12: MEMORANDUM RESPONSE TO SUBMISSIONS RECEIVED

TRAFFIC AND TRANSPORT

Proposed Oatfield Wind Farm Project, Co. Clare: ABP
Case No. ABP-318782-24

June 2024

Figure 3.1: Pinch point in road

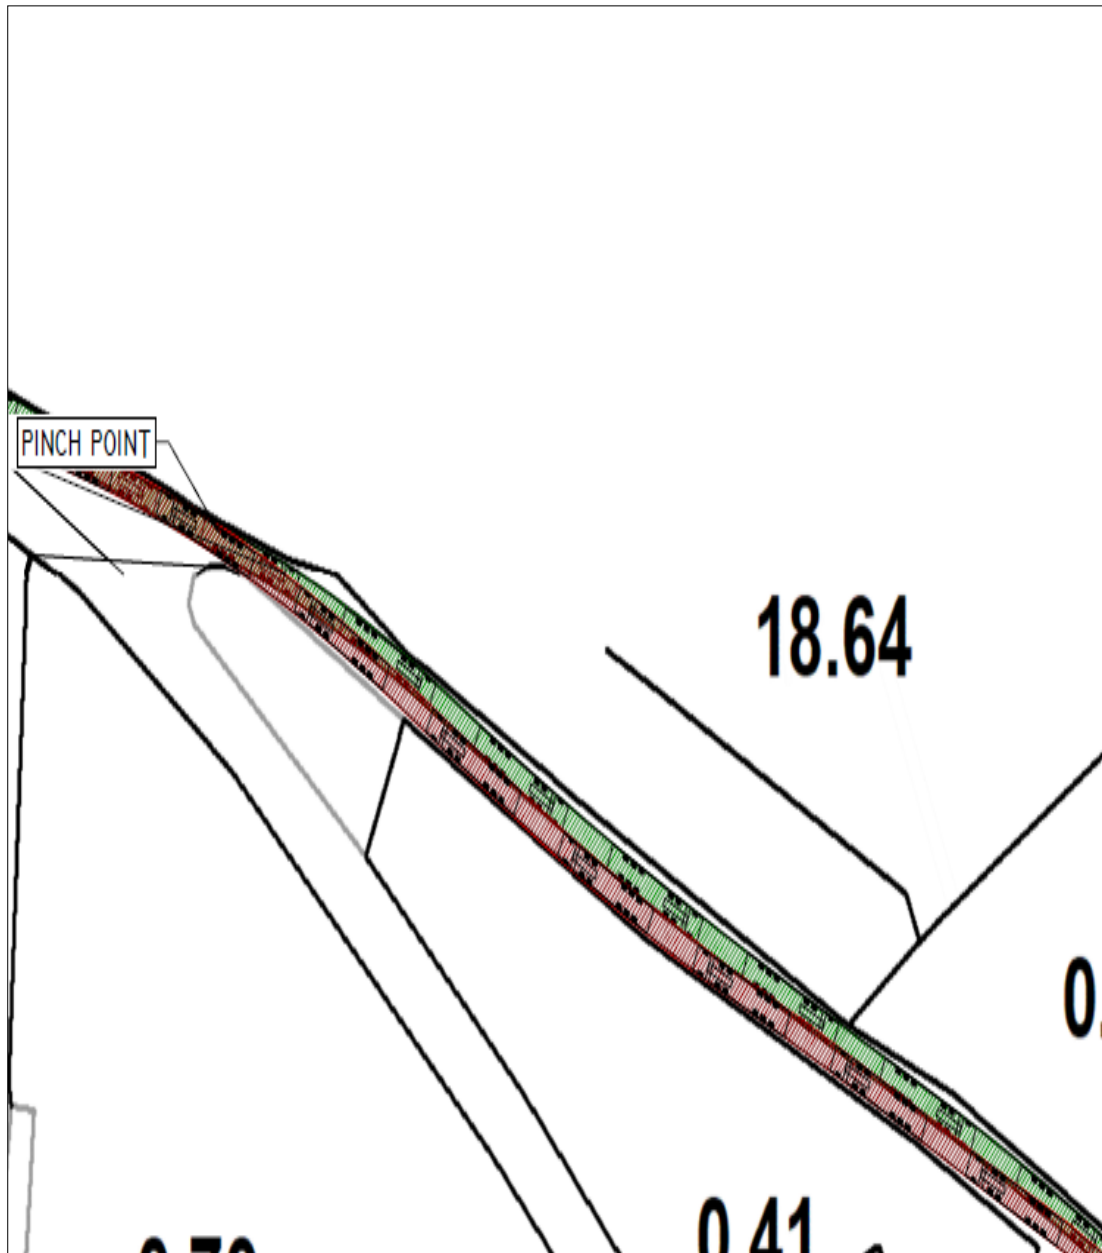
Many observations note that the proposed Haul Route and Turbine Delivery Route would be using rural roads not designed for the transportation of large volumes of construction materials.

Figure 3.1 below shows a typical narrowing in the road where two vehicles may find it difficult to pass, while Figure 3.2 shows a sample of where the road narrows to a point where only one vehicle can pass at a time. Also, Figure 3.3 shows a sample of where the road narrows to a point on approach to a bridge where only one vehicle can pass at a time.

Where it is not possible for two HGVs to pass, a stop/yield system will be introduced. Based on a line of site, a vehicle must stop to allow an oncoming vehicle to pass where the road is not wide enough for two vehicles to pass.

Upon grant of planning permission, the haul routes will be agreed with the relevant Local Authorities. Once agreed, the haul routes will be subject to a topographical survey to identify potential pinch point in more detail.
